Project	<b>IEEE 802.16 Broadband Wireless Access Working Group</b> < <a href="http://ieee802.org/16">http://ieee802.org/16</a> >	
Title	<b>Comments on SDD Key Management Protocol</b>	
Date Submitted	<b>2009-07-06</b>	
Source(s)	Yih-Guang Jan, Yang-Han Lee, Hsien-Wei Tseng, Ming-Hsueh Chuang, Jheng-Yao Lin <b>Tamkang University (TKU)</b>	yihjan@yahoo.com
	Youn-Tai Lee, Chun-Yen Hsu <b>Institute for Information Industry (III)</b>	lyt@nmi.iii.org.tw
	Shiann-Tsong Sheu <b>National Central University (NCU)</b>	stsheu@ce.ncu.edu.tw
	Whai-En Chen <b>National Ilan University (NIU)</b>	wechen@niu.edu.tw
Re:	"Comments on SDD 10.6.3 Key Management Protocol"	
Abstract	Comments on SDD Key Management Protocol	
Purpose	To be discussed and adopted by TGM for the 802.16m SDD.	
Notice	<i>This document does not represent the agreed views of the IEEE 802.16 Working Group or any of its subgroups. It represents only the views of the participants listed in the "Source(s)" field above. It is offered as a basis for discussion. It is not binding on the contributor(s), who reserve(s) the right to add, amend or withdraw material contained herein.</i>

# Comments on SDD Key Management Protocol

Figure 18 Initial or Re-authentication – Key Derivation and Exchange

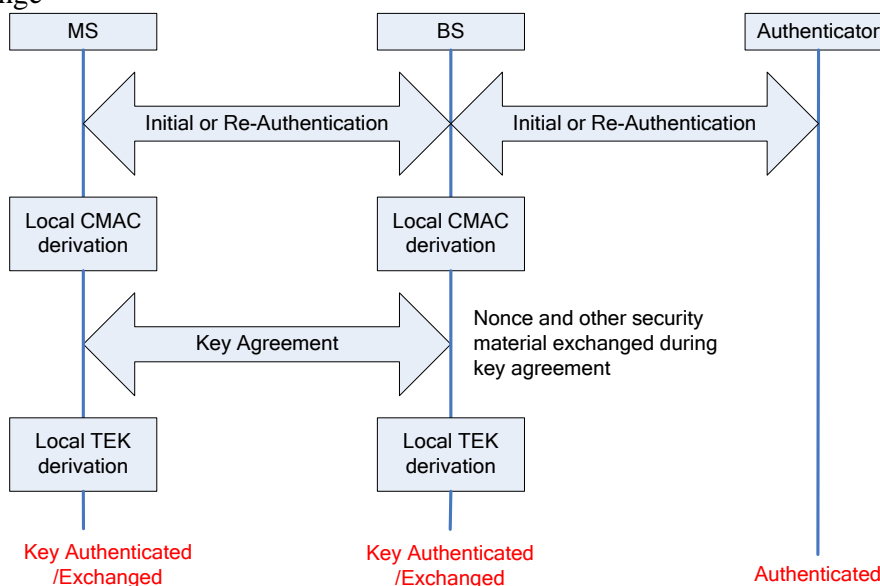
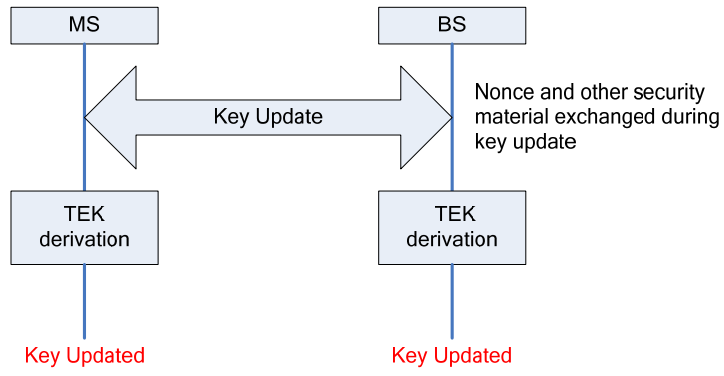
This contribution provides the corrected SDD text proposal to Pilot patterns. In Figure 18 and Figure 19, they have some entries missing and need to fill out.

*[In IEEE 80216m-08\_003r9a, Section 10.6.3.2, replace the original Figures 18 and 19 by the following modified figures.]*
